Access Compliance Report Public Rights-of-Way (Curb Ramps)

Main Street: **MERCANTILE_WAY** Cross Street: **SIENNA_PKWY** Location: **S**

ADA ID: **RPRK211022122524** Ramp Type: **Type 4 - Parallel** Initial Pass/Fail: **Fail** Overall Compliance: **No** Severity Score: **45**

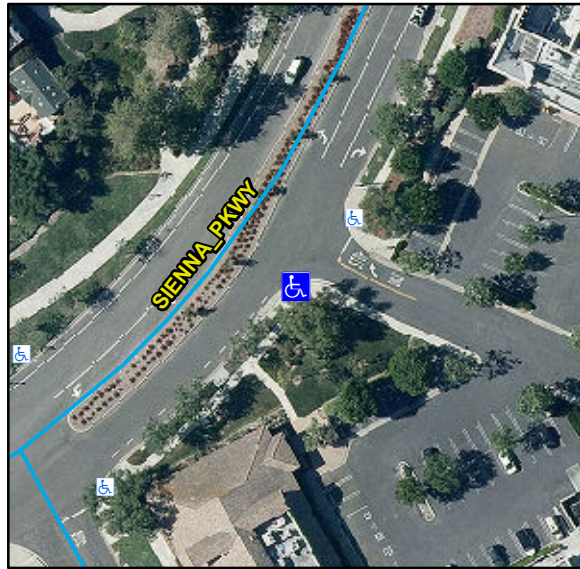
R204.3, R304.3.2, R304.5.3, STD 1115

Compliance	Description	Data	Compliance	Description	Data
N/A	Ramp Length LT (in)	100	N/A	Ramp Length RT (in)	100
Yes	Ramp Width LT (in)	115	Yes	Ramp Width RT (in)	115
Yes	Ramp Run Slope LT (%)	4.2	No	Ramp Run Slope RT (%)	8.7
Yes	Ramp Cross Slope LT (%)	0.2	No	Ramp Cross Slope RT (%)	7.2
N/A	Landing Present	N/A	N/A	DWS Provided	N/A
N/A	Landing Length (in)	N/A	N/A	DWS Contrast	N/A
N/A	Landing Width (in)	N/A	N/A	DWS Length (in)	N/A
N/A	Landing Run Slope (%)	N/A	N/A	DWS Full Width	N/A
N/A	Landing Cross Slope (%)	N/A		DWS Offset Type	N/A
N/A	Landing Movement Obstructed?	N/A	N/A	DWS Offset Left (in)	N/A
	Landing Movement Type	N/A	N/A	DWS Offset Right (in)	N/A
N/A	Landing Shared	N/A			
N/A	Clear Space	Yes			
N/A	Clear Space To Crosswalk (in)	N/A			
N/A	Marked Crosswalk 1	No	N/A	Marked Crosswalk 2	No
	Crossing 1 Direction	NE		Crossing 2 Direction	NW
	Marked Crosswalk 1 Width (in)	N/A		Marked Crosswalk 2 Width (in)	N/A

Remove & Replace Curb Ramp With Two New Directional Ramps or Equivalent.
